Service Bulletin

No. : MZ07-106 3rd

Model: SR6001, SR7001 SR8001

Subject: The thermal sensor is sometimes activated, which shuts down the unit putting the unit into standby.*

Fig.1

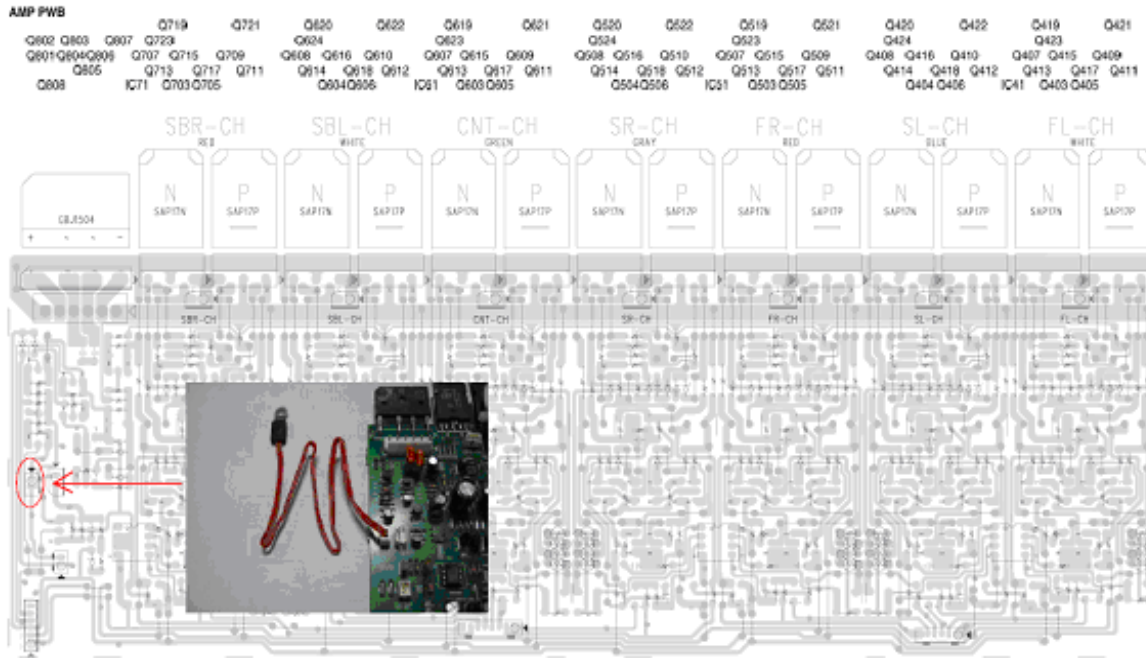
2. Cut the white plastic connector (CN81) off the new Heat Sensor then strip ¼ inch (approx.) of insulation from the end of the lead and tin each end of the lead wire. (Fig. 1)

Fig.2

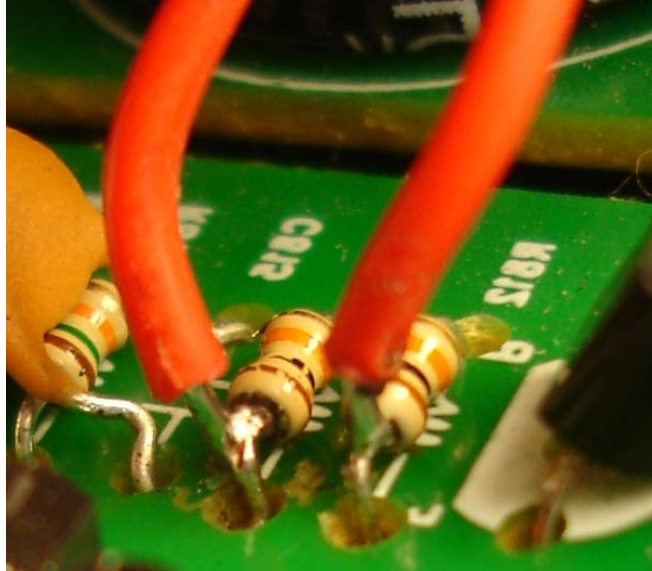
3. Solder the stripped ends of the lead wires to resistors R811 and R812 as shown below.

Fig. 3

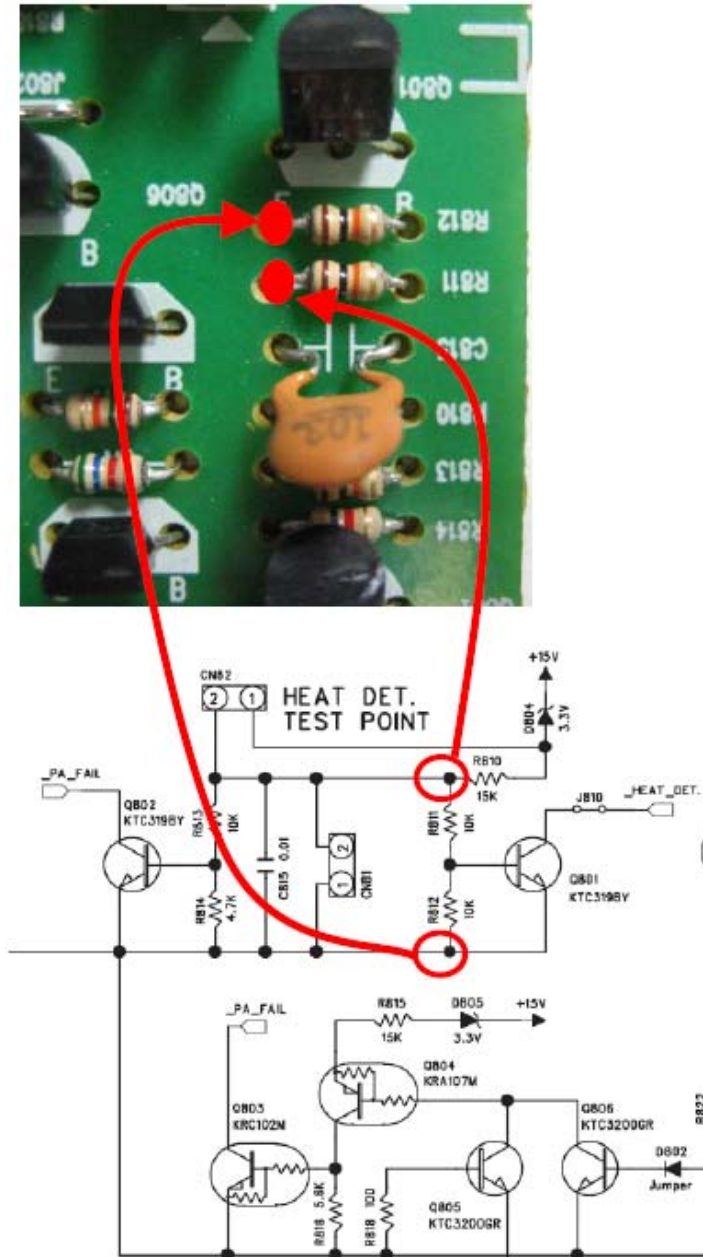
Note: The Heat Sensor has no polarity however, be certain to connect the sensor to the side of each resistor that corresponds (electrically) to connector CN81's pins 1 & 2. Do not solder the leads to the side of resistors R811 and R812 that are closest to the base of transistor Q801. See Figure 3 for details.

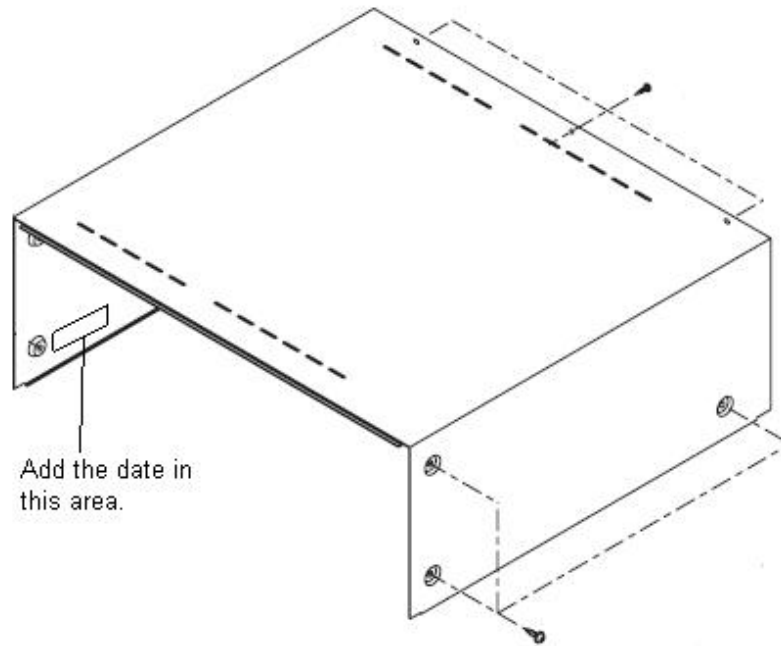
4. Fix the soldered wire ends to the resistors using Sony® bond SC608Z or Dow Corning® SE 9188 RTV high temperature RTV.
